APPLICATION AND PRELIMINARY PLAT CHECKLIST

Name of Proposed Subdivision Rockwall Towne Centre
Name of Subdivider Dunning Development Company
Address 8235 Douglas Ave., Suite 816, Dallas, TX 75225 Phone 214/528-1905
Owner of Record Rockwall Village LTD
Address 8235 Douglas Ave., Suite 816, Dallas, TX 75225 Phone 214/528-1905
Name of Land Planner/Surveyor/Engineer Wier & Associates
Address 3908 S. Freeway, Ft. Worth, TX 76110 Phone 817/926-0212
Total Acreage 21.95 AC Current Zoning Commercial
No. of Lots/Units 6 Signed [Signature]

RE: Rockwall Towne Center

SUBJECT: Rockwall Towne Center Site Plan
DATE: 8/31/84

SITE PLAN
 ROCKWALL, TEXAS
 4/15/85
 5/10/85 REVISED

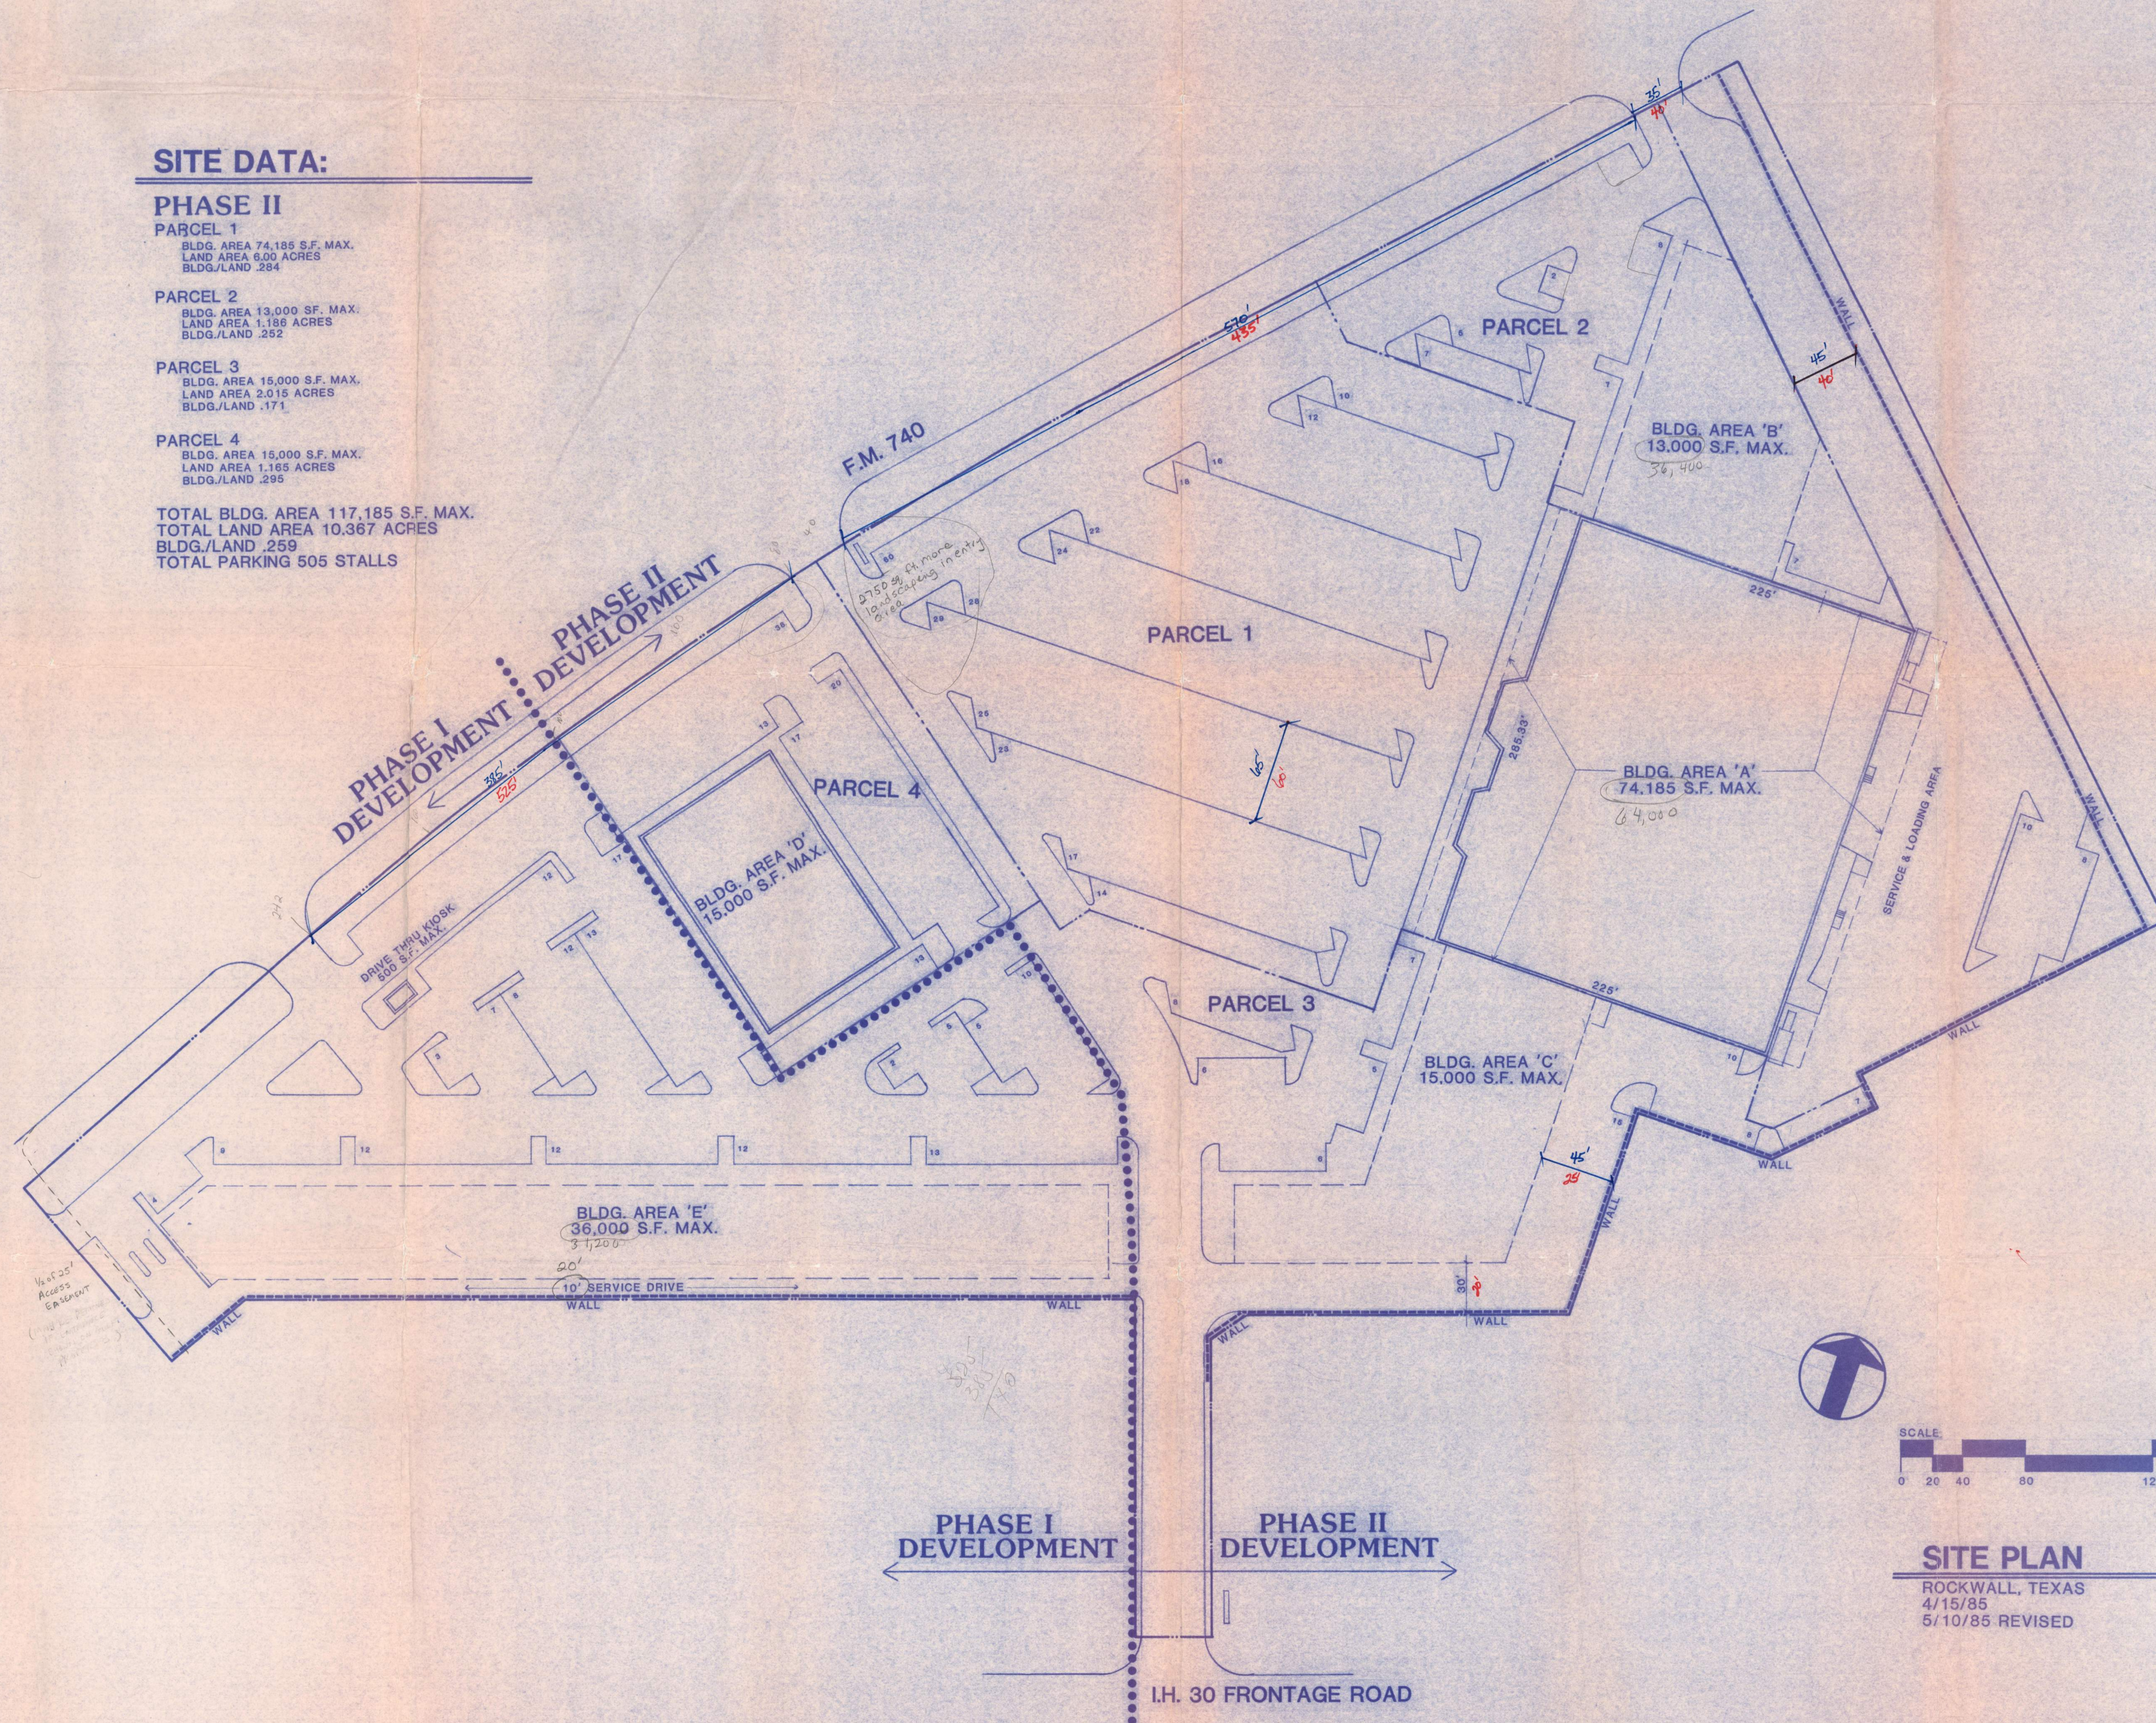
Attached is a revised site plan for our shopping center in Rockwall. I have compared the city approved site plan with the attached and illustrated a few minor changes. The red ink represents what the city approved, and the blue ink is what we would like to change.

ROCKWALL TOWNE CENTER

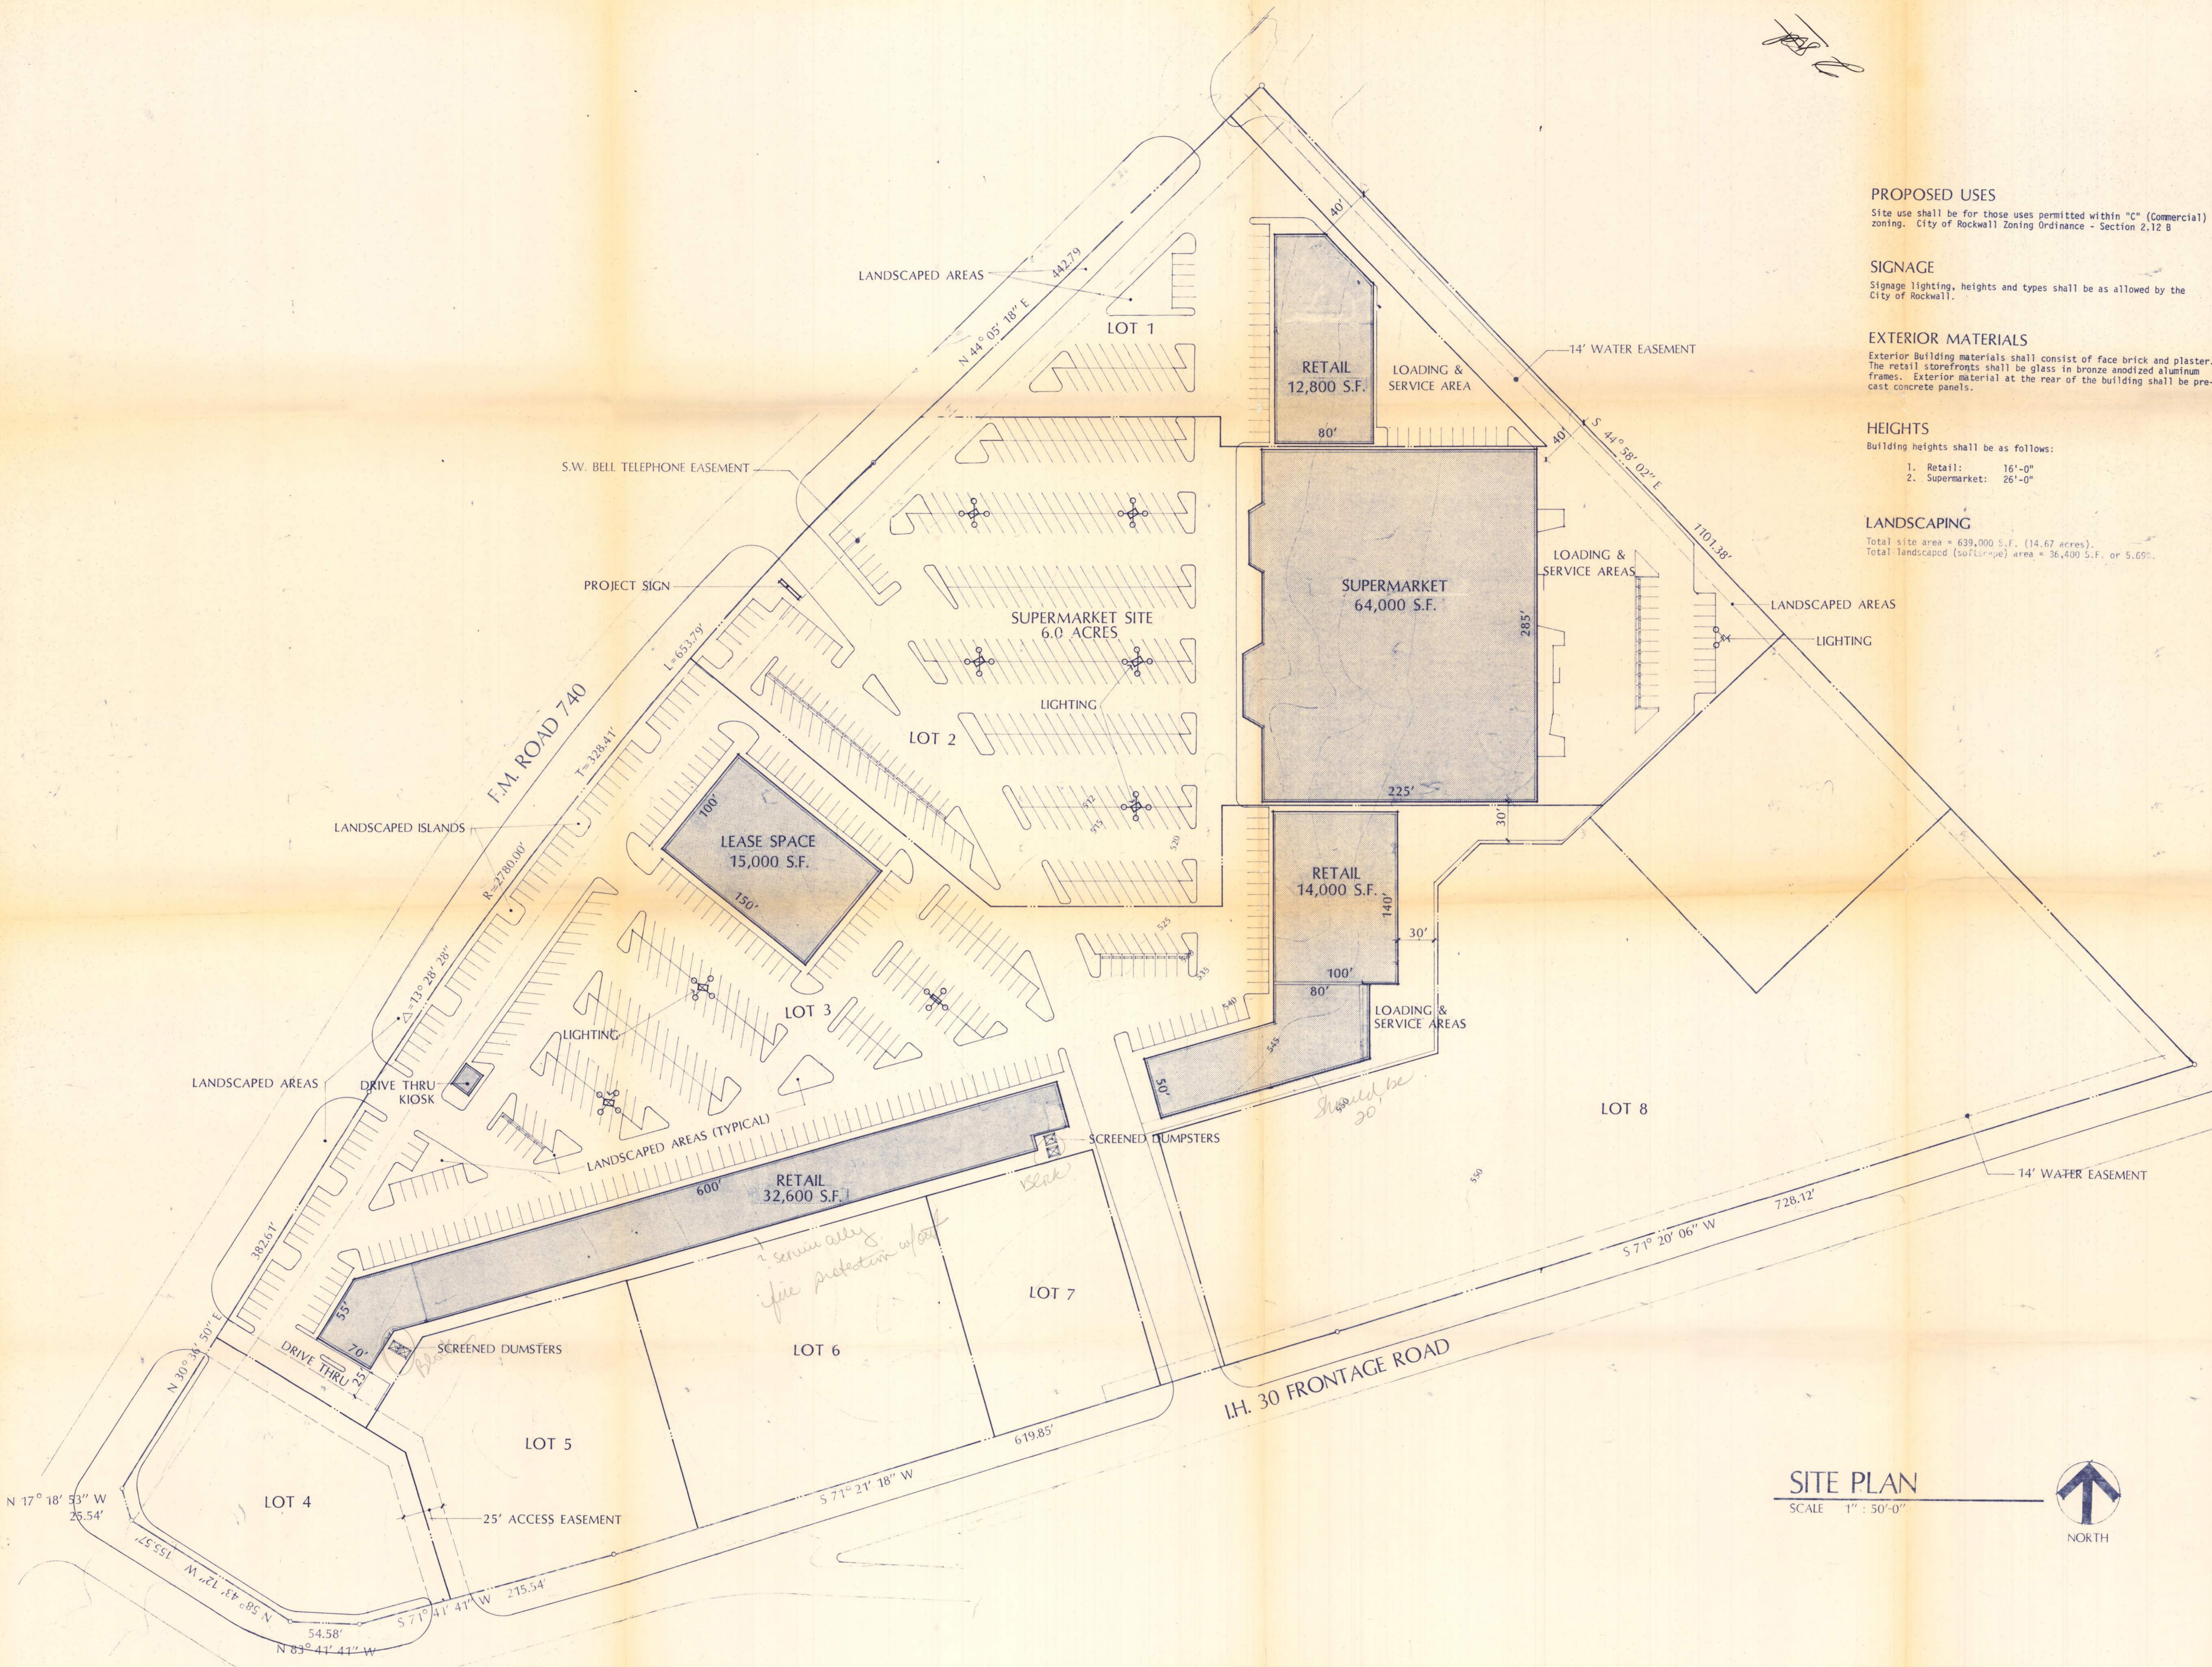
what are the dumpsters going

looks like total square footages app
9570 sq if a rest has 1400 sq need
a total of 55 parking spaces, have
~~exactly~~ 47 shown in Phase 1

as the landscaping in blue going
to occur
